Comments and Responses Volume 5

San Francisco Public Utilities Commission CALAVERAS DAM REPLACEMENT PROJECT

San Francisco Planning Department File No. 2005.0161E
State Clearinghouse No. 2005102102

Comments and Responses Publication Date: January 5, 2011

FIGURE 1: CALAVERAS DAM REPLACEMENT PROJECT AND MITIGATION AREAS LOCATOR MAP (UPDATED)

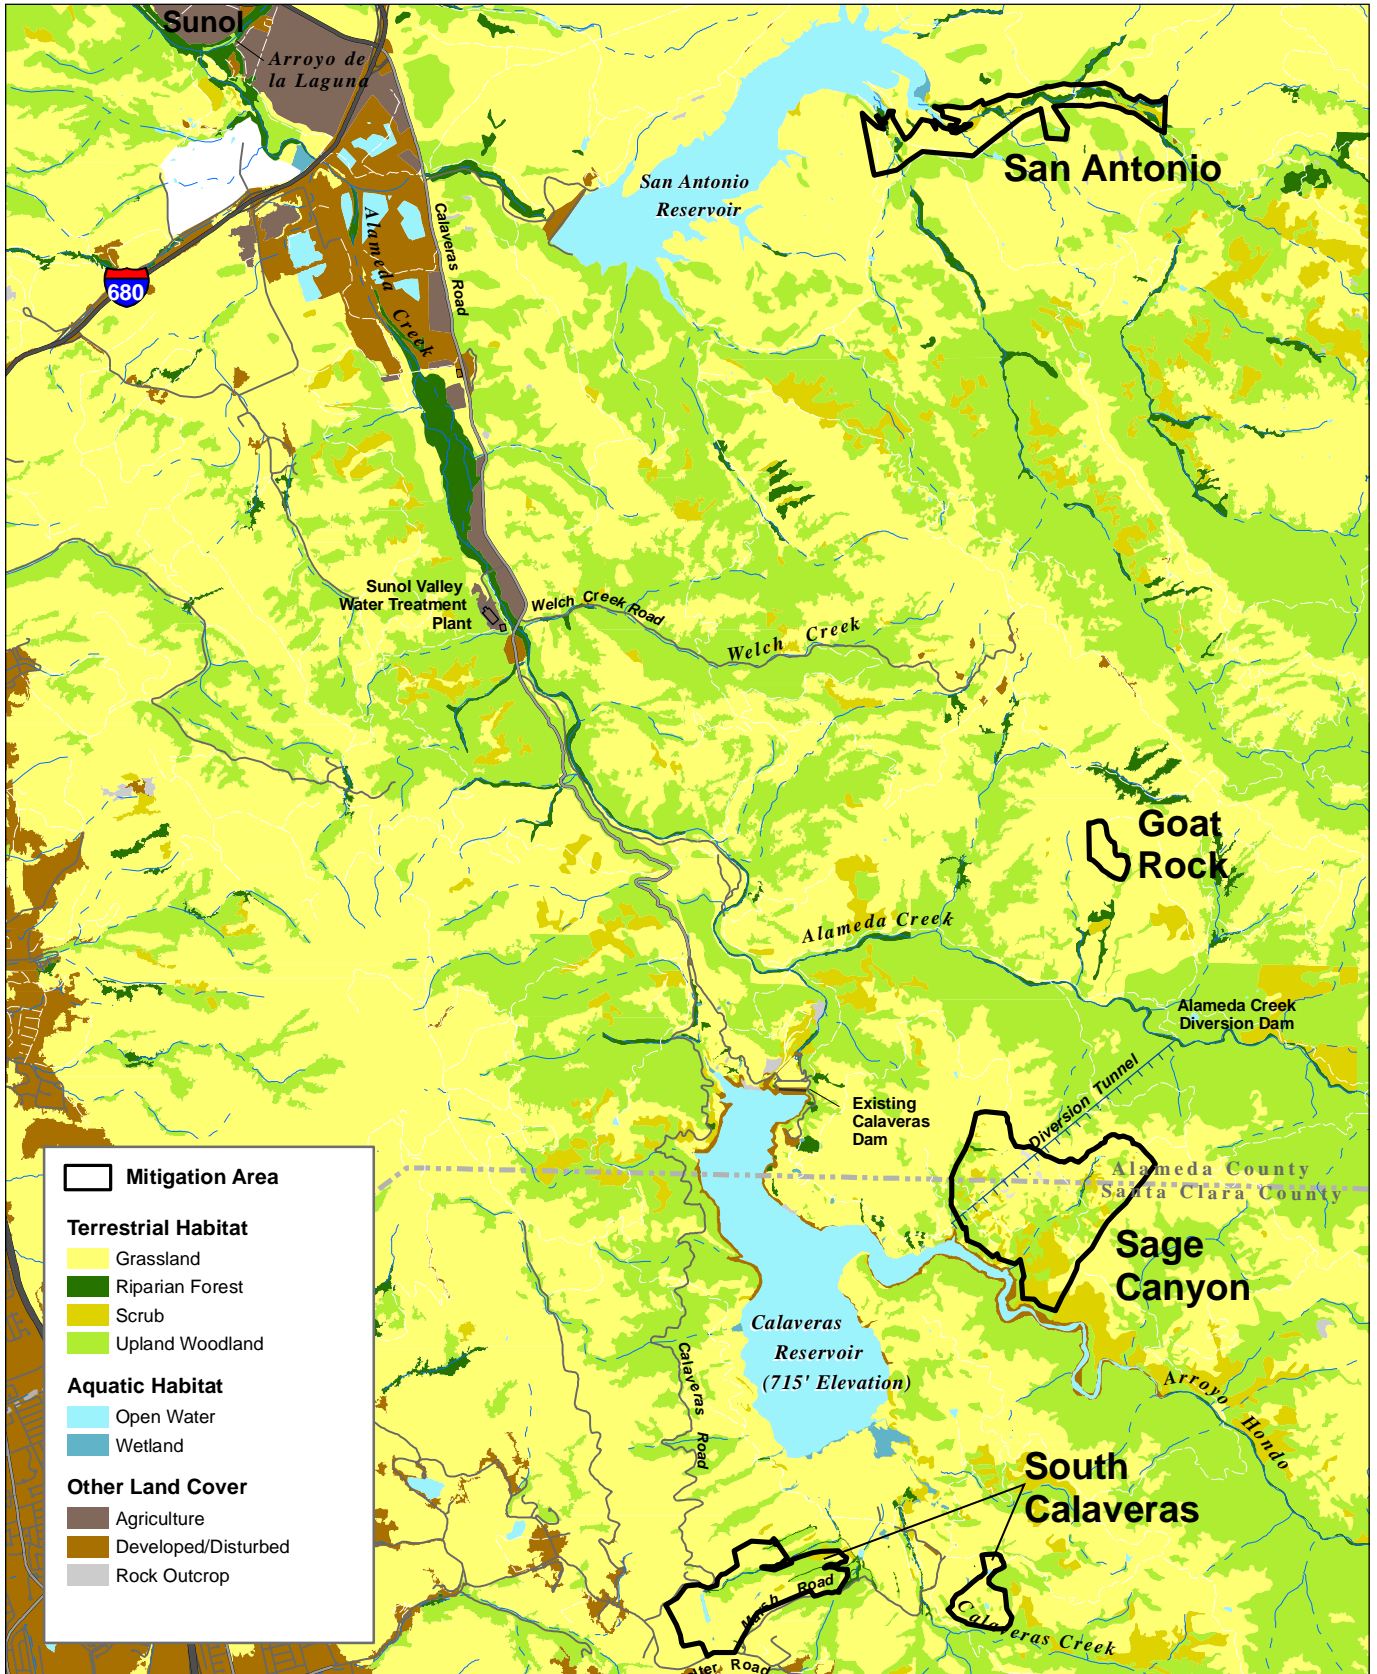
Figures 1 and 2 are updated to show the revised boundaries at the South Calaveras, San Antonio, and Sage Canyon mitigation areas. The boundary of the Goat Rock mitigation area has not changed since the original June 22, 2009 memo was prepared and is not addressed further.

Figures 1 and 2 and the photo appendix, below, are added to Appendix C.2 to show updated boundaries and photos of the CDRP mitigation areas.

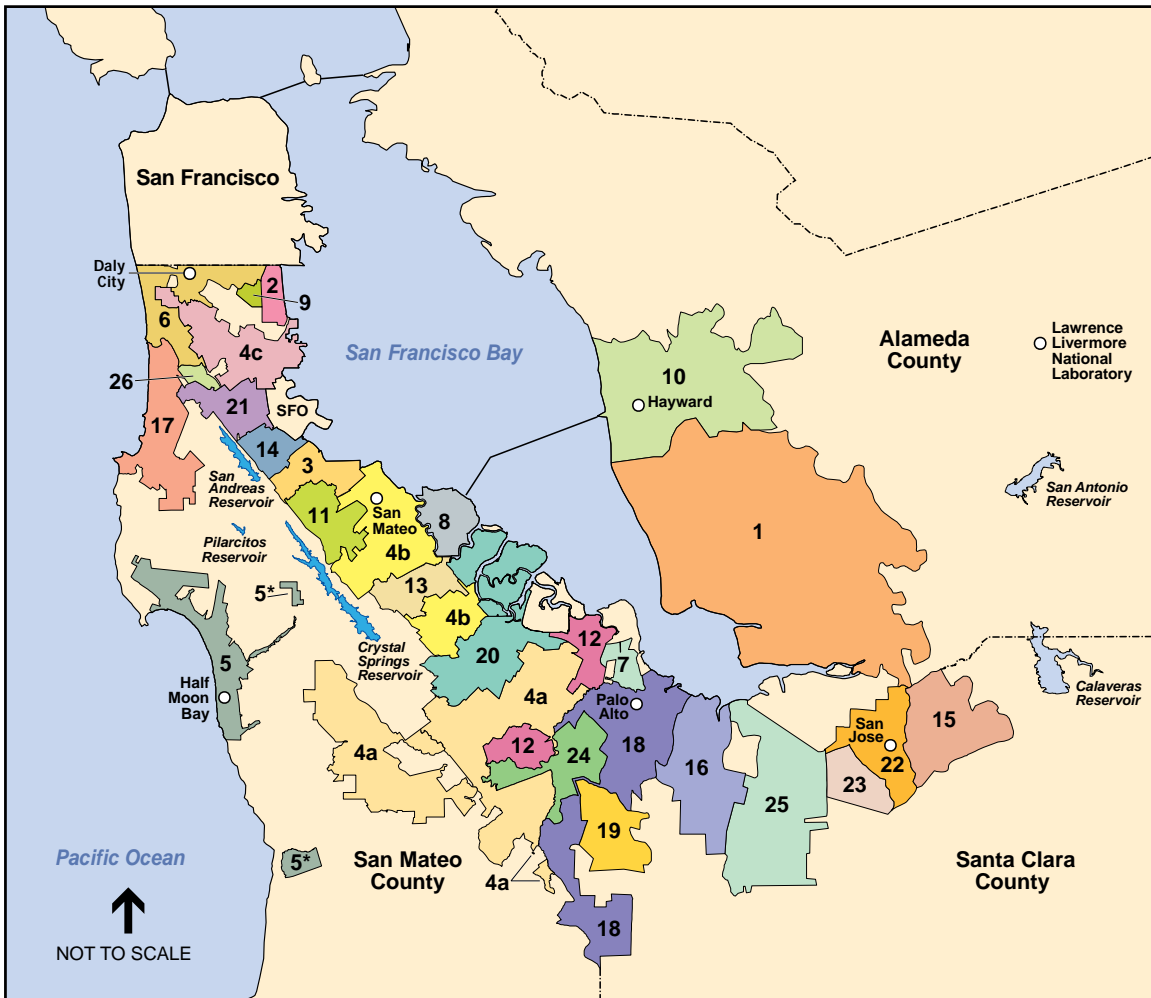
The wholesale customers are largely represented by the Bay Area Water Supply and Conservation Agency (BAWSCA), which consists of ~~27~~ 26 total customers, shown in Figure 2.2, SFPUC Water Service Area – San Francisco and SFPUC Wholesale Customers. Some of these wholesale customers have other sources of water in addition to what they receive from the SFPUC regional water system, while others rely completely on the SFPUC for supply.

Figure 2.2, SFPUC Water Service Area – San Francisco and SFPUC Wholesale Customers, on EIR page 2-4, is revised to show this change in the number of BAWSCA customers (two BAWSCA customers have merged) and to identify the areas of the Coastside County Water District that are not served by the SFPUC. The revised figure is shown on the following page.

FIGURE 4.6.17: DEPTH OF FLOODWATERS FROM MODELED BREACH OF CALAVERAS DAM (REVISED)

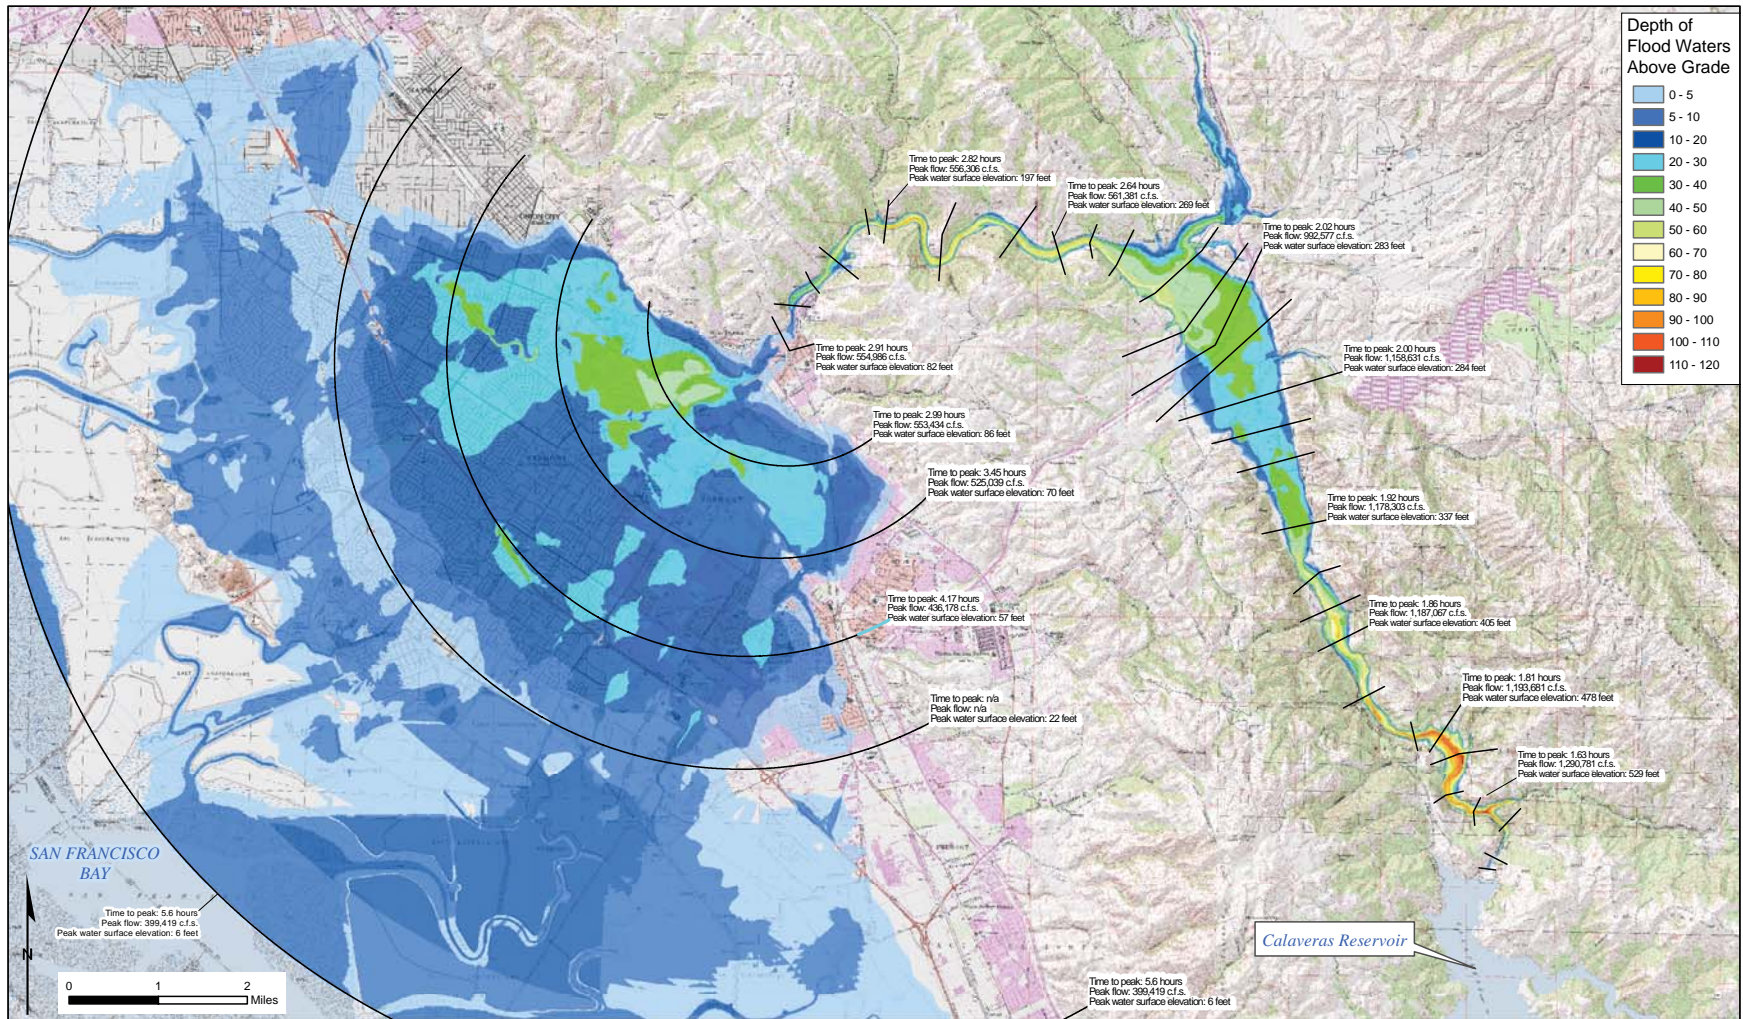
The source shown on Figure 4.6.17: Depth of Floodwaters from Modeled Breach of Calaveras Dam, on EIR page 4.6-101, is revised. The revised figure is shown on the following page.

FIGURE 4.10.1: CULTURAL RESOURCES STUDY AREA AND WORK LIMIT AREA (REVISED)

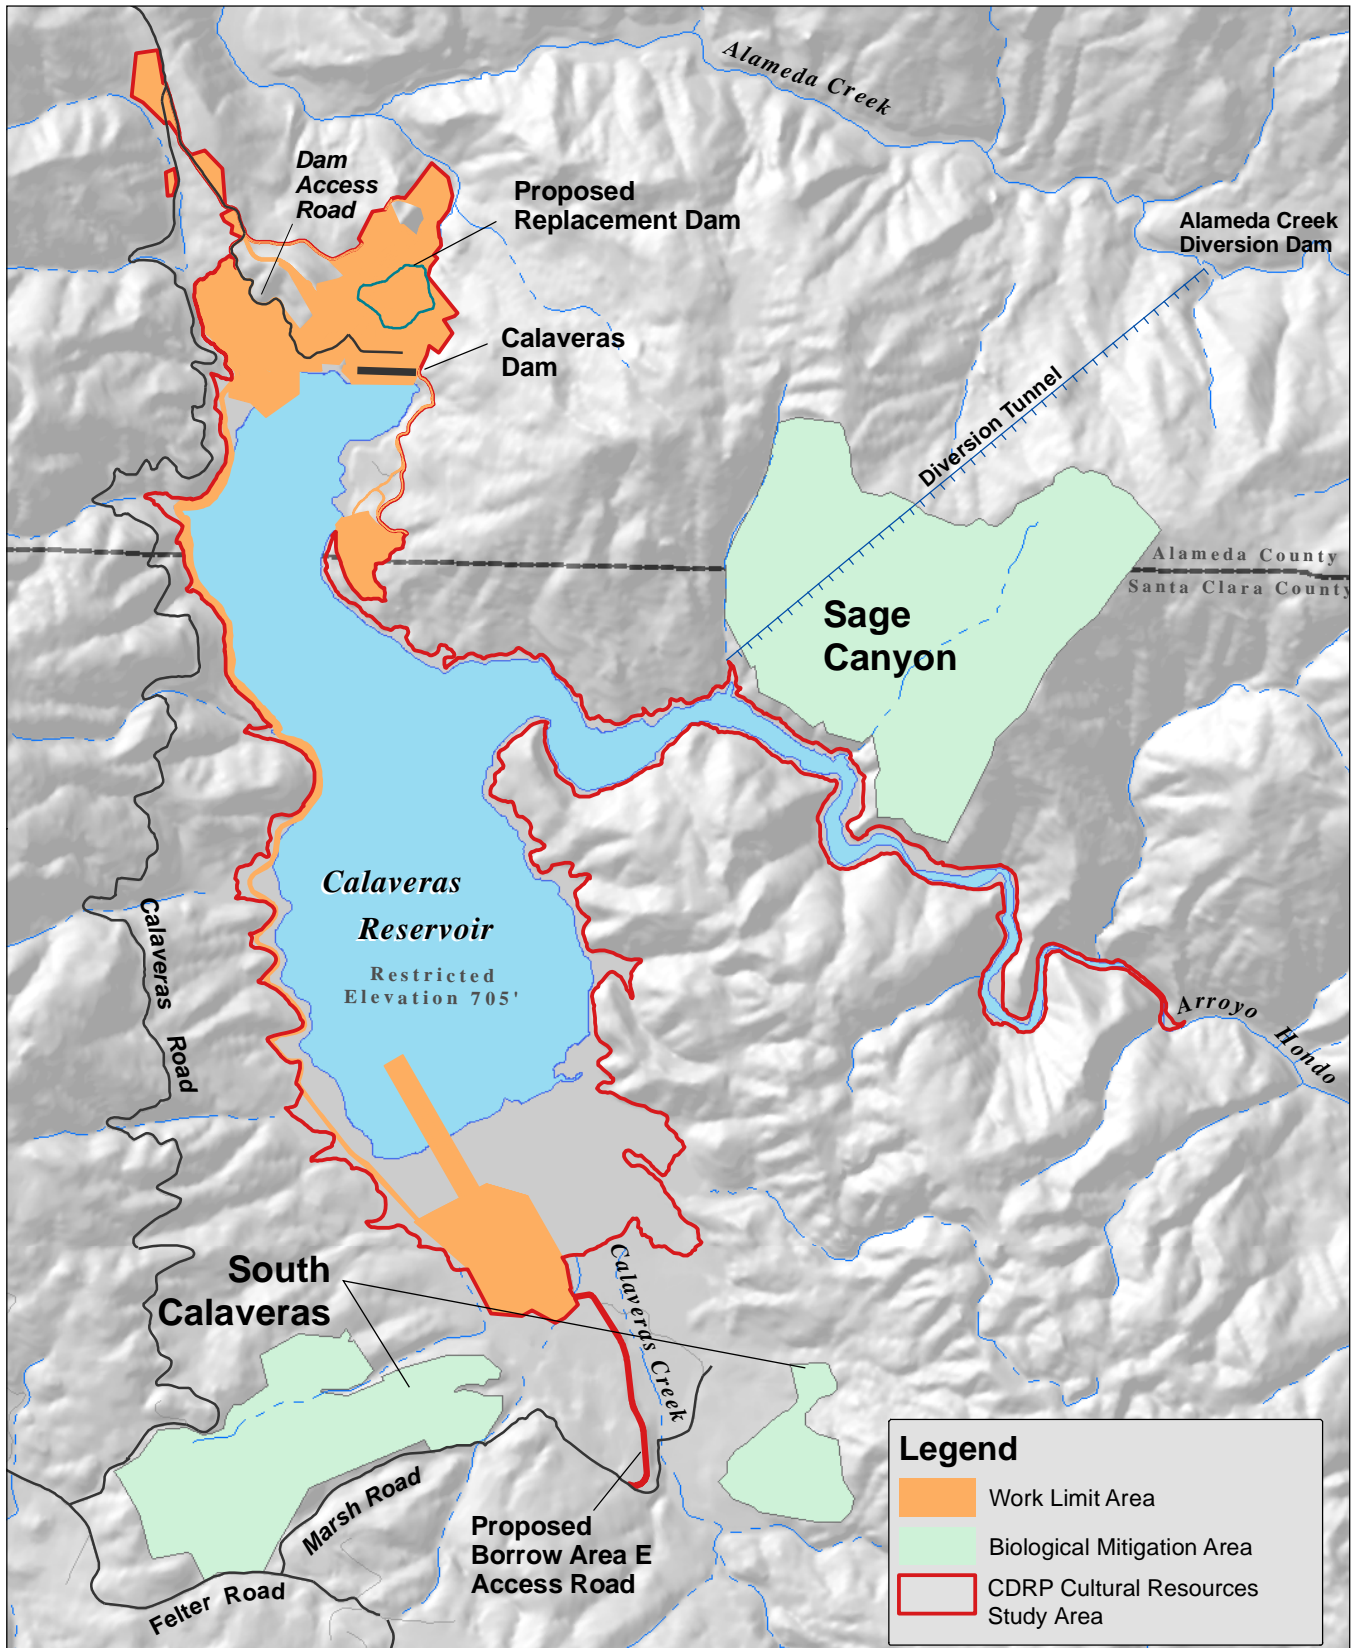
Figure 4.10.1: Cultural Resources Study Area and Work Limit Area, on EIR page 4.10-3, is updated to show the revised South Calaveras Mitigation Area boundary (the Koopmann Road Mitigation Area is not on this figure but is detailed in Appendix C.3). The revised figure is shown on the following page.

Also shown on Figure 4.10.1 are two Biological Mitigation Areas (South Calaveras and Sage Canyon) that are adjacent to the Study Area. These areas are among the ~~four~~ five Biological Mitigation Areas that have been identified as suitable potential locations within which habitat restoration efforts to mitigate the CDRP's adverse impacts on biological resources are proposed. The other three, San Antonio, Goat Rock, and Koopmann Road, are beyond the area shown in Figure 4.10.1, and are discussed in Section 4.4, Vegetation and Wildlife on pp. 4.4-73 – 4.4.74. All five mitigation areas have been surveyed for cultural resources as part of the analysis for the EIR.

FIGURE 6.1: LOCATION OF CUMULATIVE PROJECTS IN THE SUNOL VALLEY REGION (REVISED)

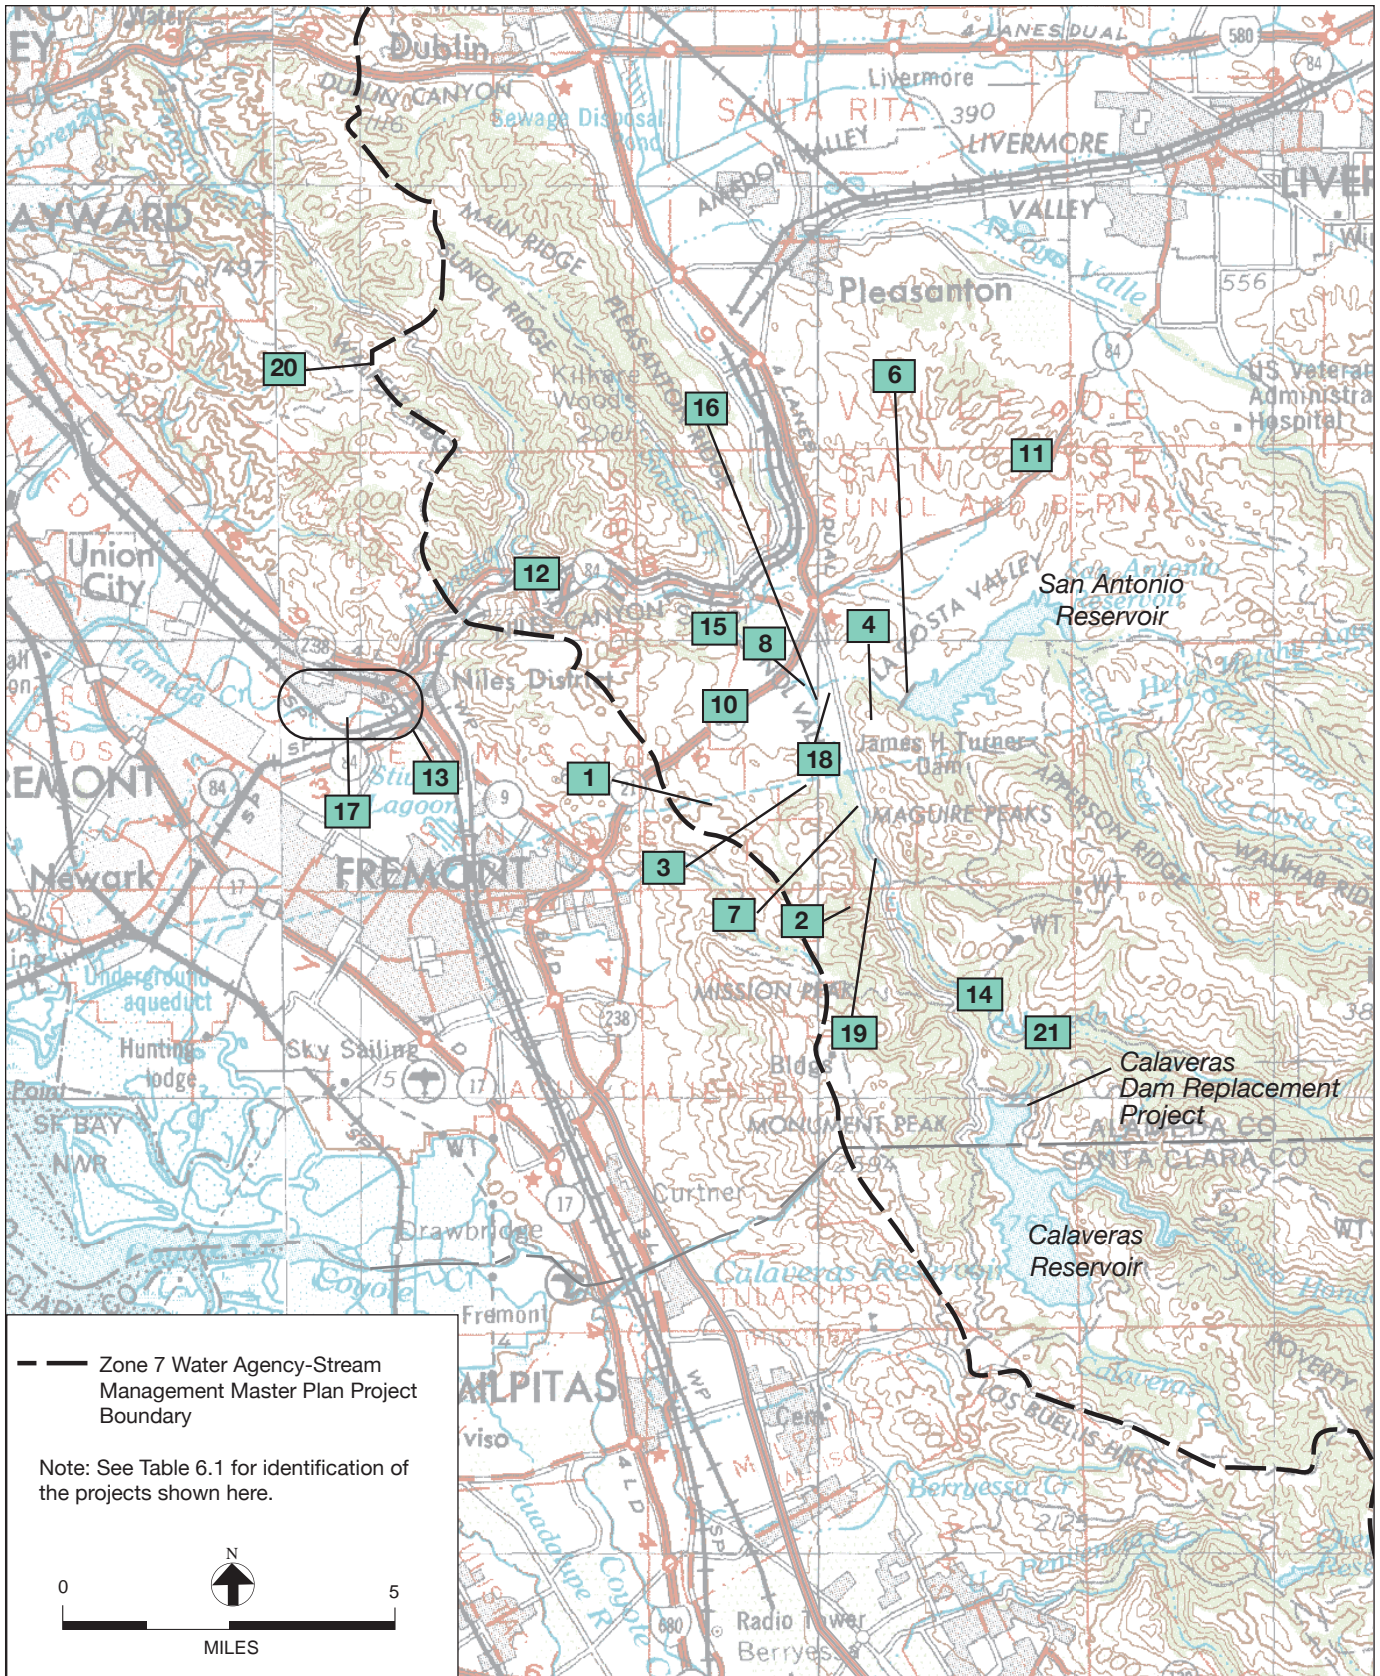
Figure 6.1: Location of Cumulative Projects in the Sunol Valley Region, on EIR page 6-18, is revised to delete the WSIP Habitat Reserve Program Project Boundary shown in the legend and in the figure itself, and to add Project No. 21, Modification of Natural Barriers in the Alameda Creek Watershed, that is added to Table 6.1. The revised figure is shown on the following page.
